On June 18, 2019, the Yarmouth Planning Department approved your Building & Lot Plan application for Pat's Pizza Kitchen Addition at 791 US Route 1, Map 33 Lot 87-A, based on the application, plans, reports and other information submitted by the applicant, Chris Kyle, on behalf of the Owner, John Kyle, subject to the conditions of approval as detailed below.

Consolidated Review Committee
Review, Findings, and Waiver Recommendation
John Kyle – Pat's Pizza
791 Route 1
Map 33 Lot 87A
CD4-C2 Standards Review
Site Plan for standards covered by CBDC
July 18, 2016

Re: Minor Site Plan Application Review for Pat's Pizza, 791 US Route 1

To: Nicholas Ciarimboli < NCiarimboli@yarmouth.me.us Subject: FW: Pats Pizza Site Plan Tree Planting 6-17-19

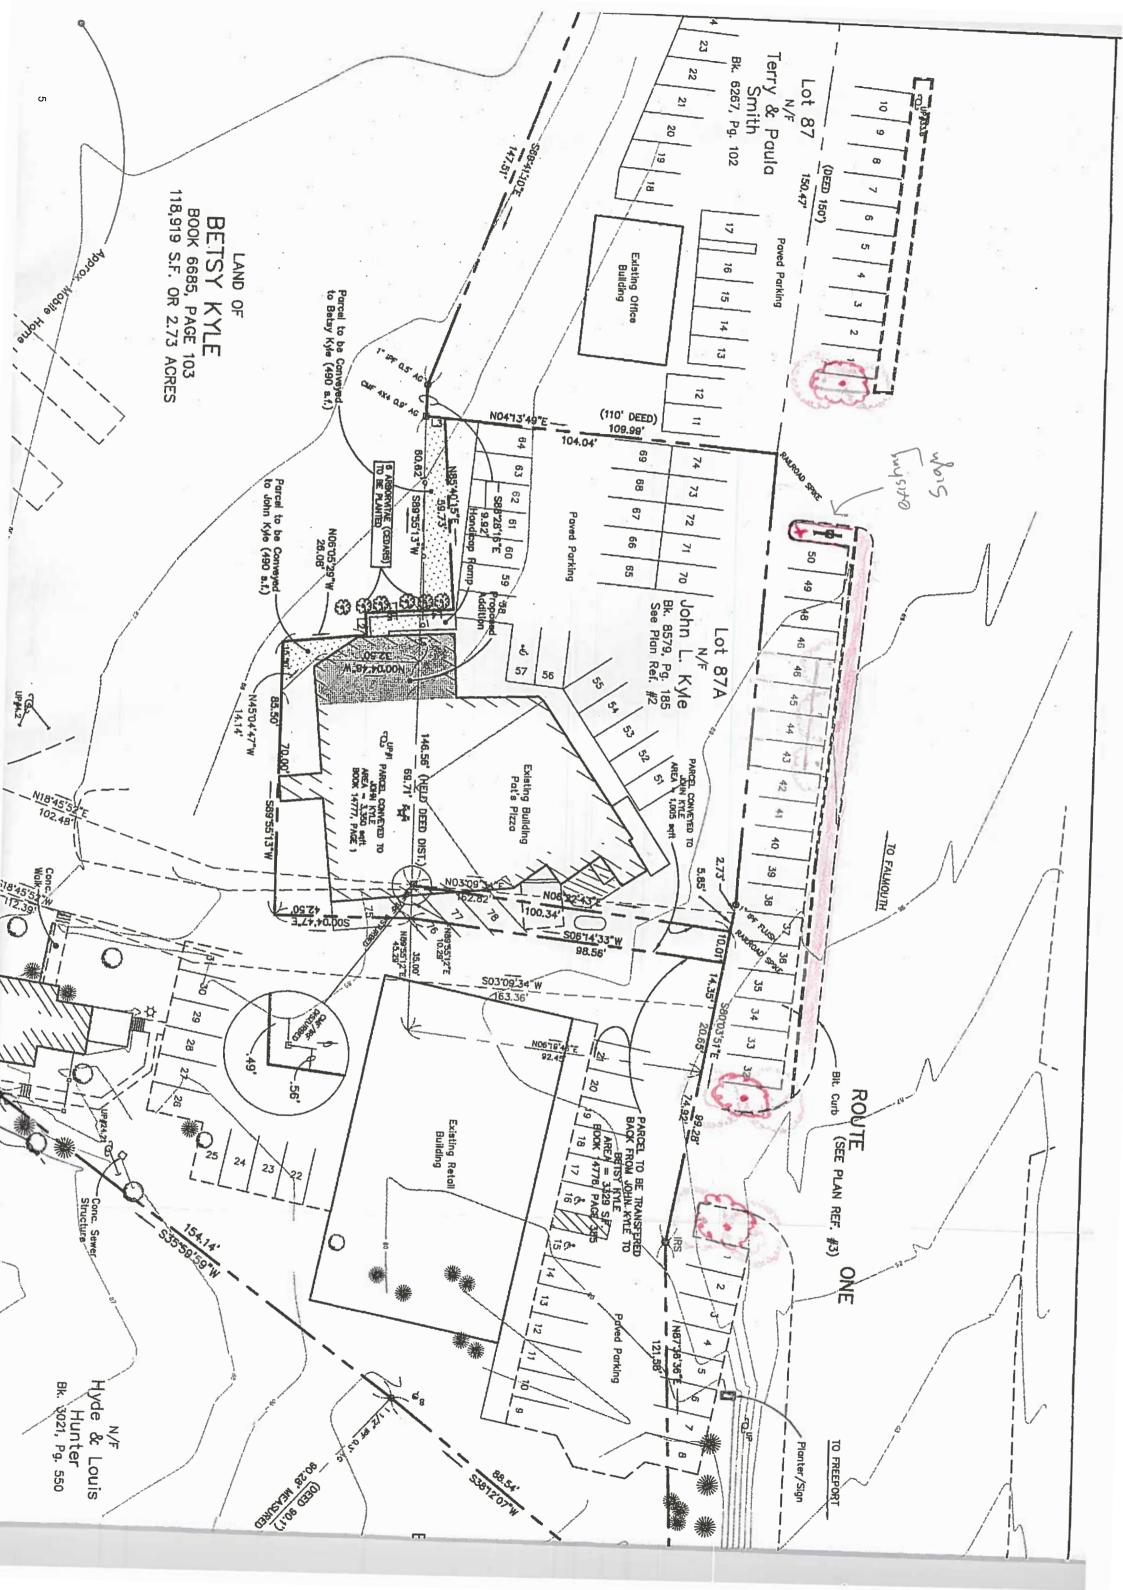
After deliberating, my request for the Pat's Pizza cooler addition site plan is to defer any sidewalk improvements at this time, with the understanding that future site development or improvements will require either a sidewalk to be installed or a contribution for the estimated cost of a sidewalk across the Rt. 1 frontage. The earlier plan for tree plantings would have required trees in the area where a sidewalk could be located. I have reduced the tree requirement to just three street trees, which shall be of a variety listed in Chapter 703.6.E.4. Ginkgo Biloba (Maidenhair Tree) is described as salt tolerant and columnar in form, a good choice for this location given the limited area. (Armstrong Maple might also be a good columnar tree choice, but is not described as salt tolerant.)
